VILLAGE OF GERMANTOWN
N112 W17001 MEQUON ROAD
GERMANTOWN, WI 53022

MEETING:	PLAN COMMISSION
DATE AND TIME:	MONDAY, August 13, 2018 6:30 p.m.
LOCATION:	Germantown Village Hall Board Room

8/13/18 Plan Commission Meeting

SITE PLAN & SIGN REVIEW

PROPOSED EXTERIOR ELEVATIONS

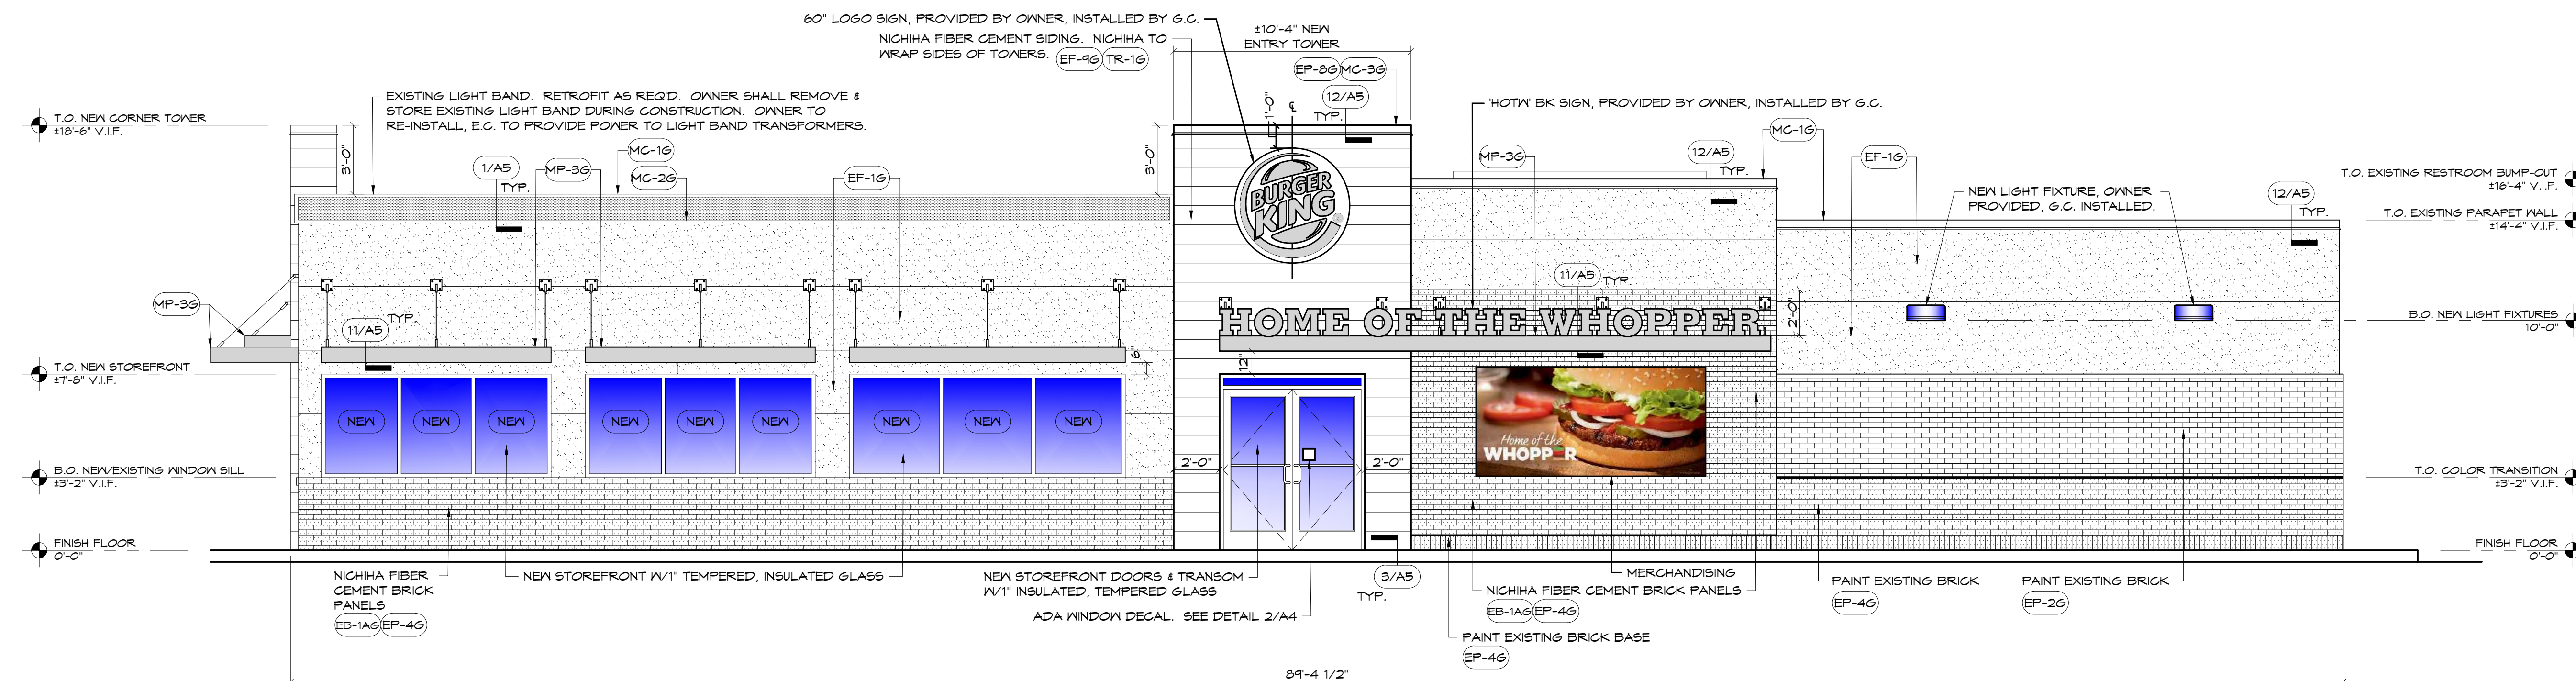
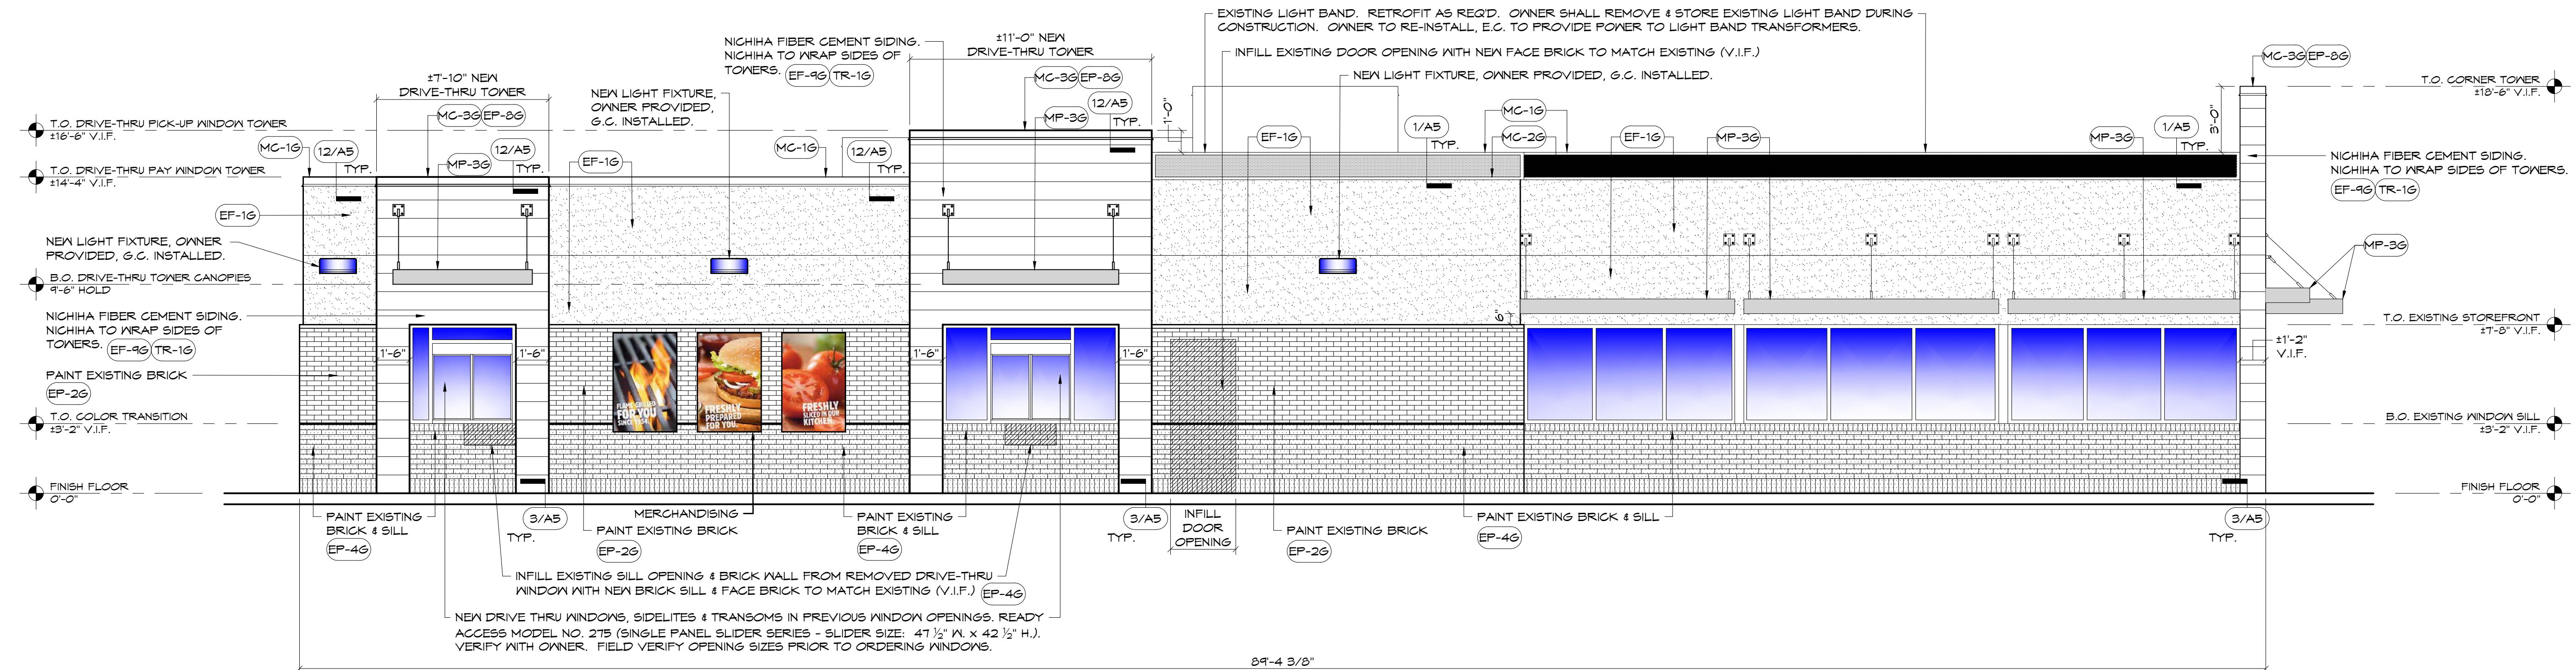
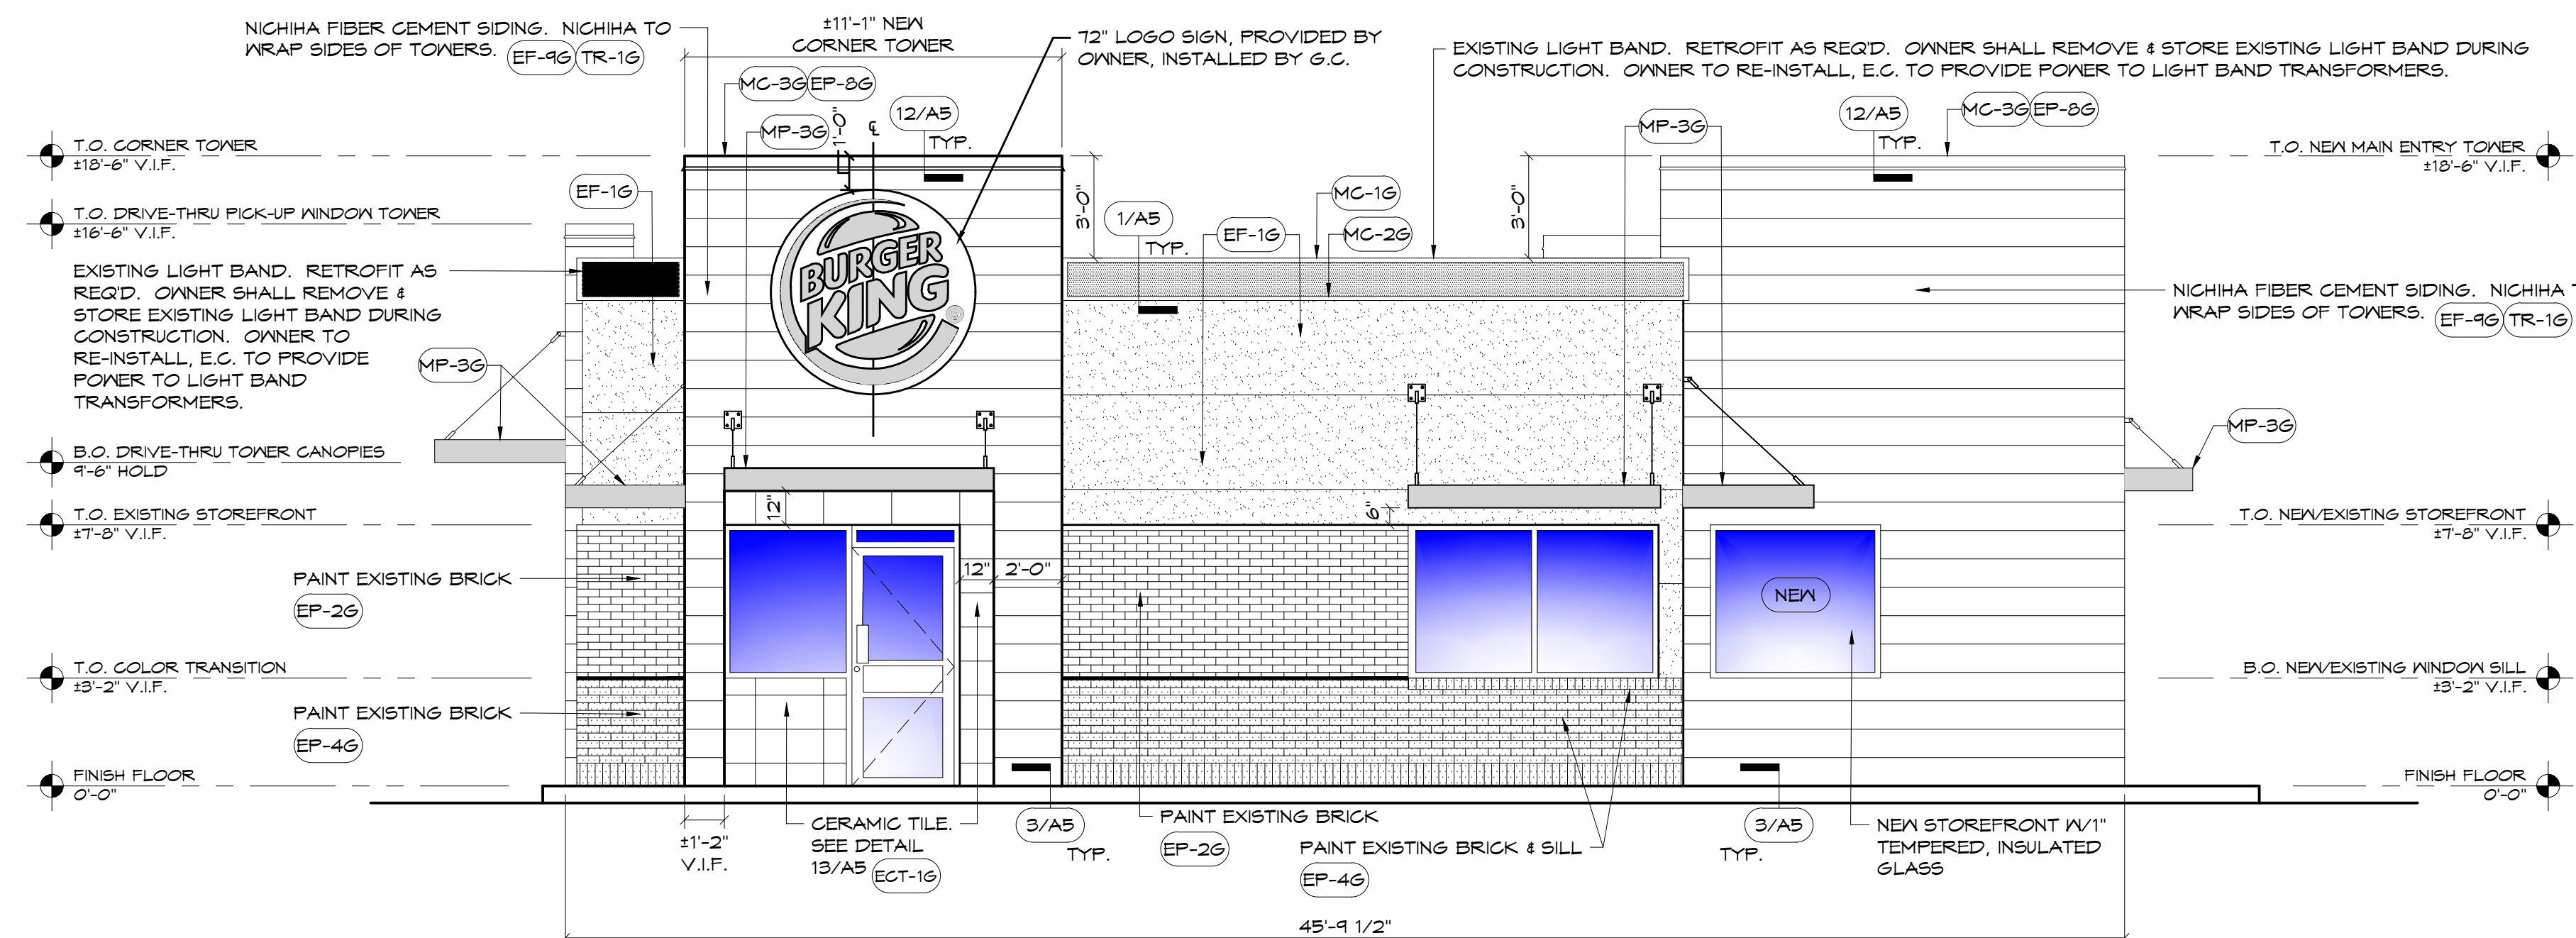
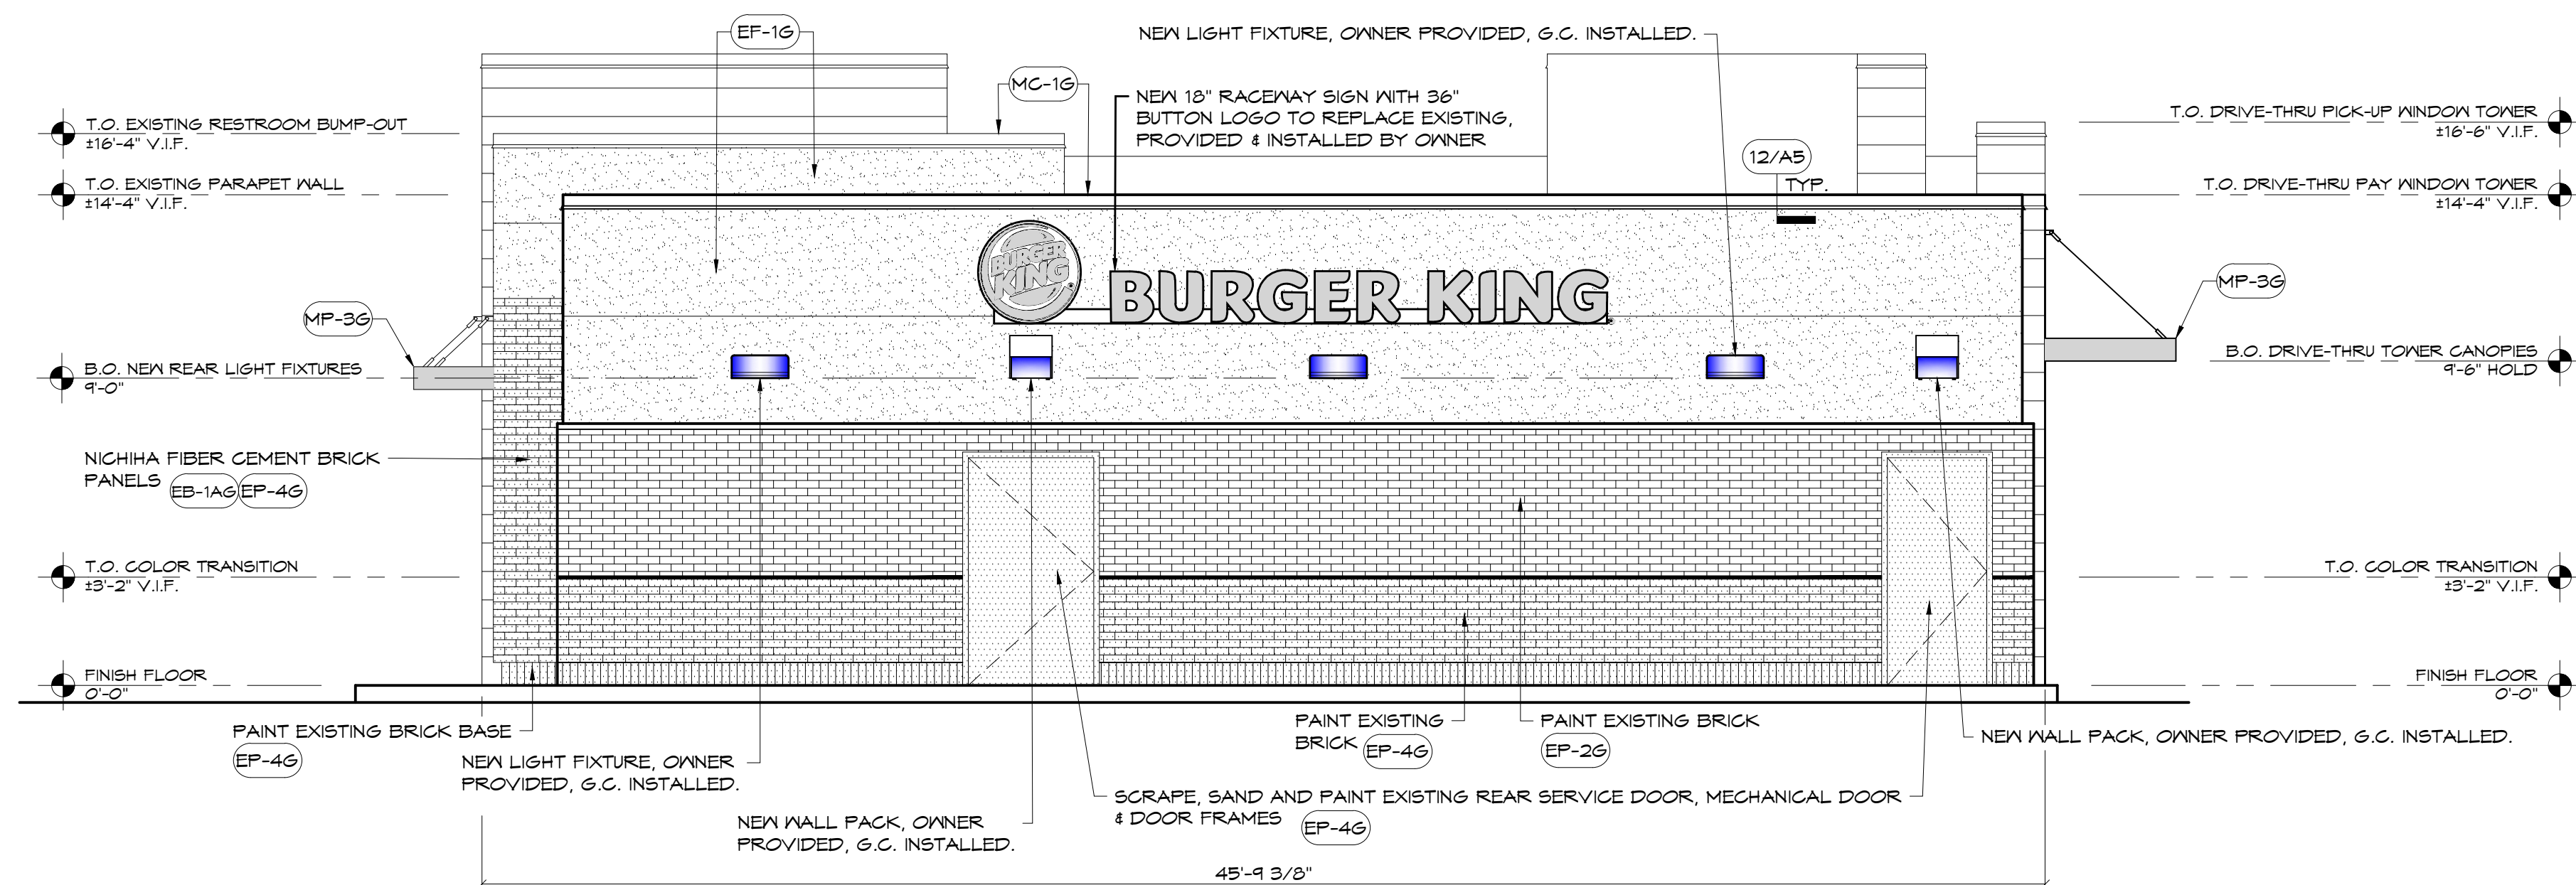
Roof top mechanical screening is not addressed in the site plans, but should be considered. Aerial views of the site show four (4) existing RTU’s on the roof that are hidden from view by the existing mansard roof and/or parapet walls. Because the mansard roof is being removed, the new tower features and/or wall elements should be used to hide the existing (and any new) RTU’s on the building.

The proposed merchandising signs on the south elevation are considered signage in the context of the Village’s Zoning Code. The Plan Commission can approve such additional signage on non-street-facing building elevations, but historically, such signage has not been approved (ex: KFC across the street).

4. Existing and/or new roof-mounted HVAC and other mechanicals shall be installed, re-positioned or screened to not be visible from County Line Road.
5. All technical issues identified by the Village Engineer and Public Works Department staff presented in the August 10, 2018 Village Engineer memo shall be addressed and reflected in revised plans and/or supplemental information reviewed and approved by the Village Engineer prior to issuance of a building permit.
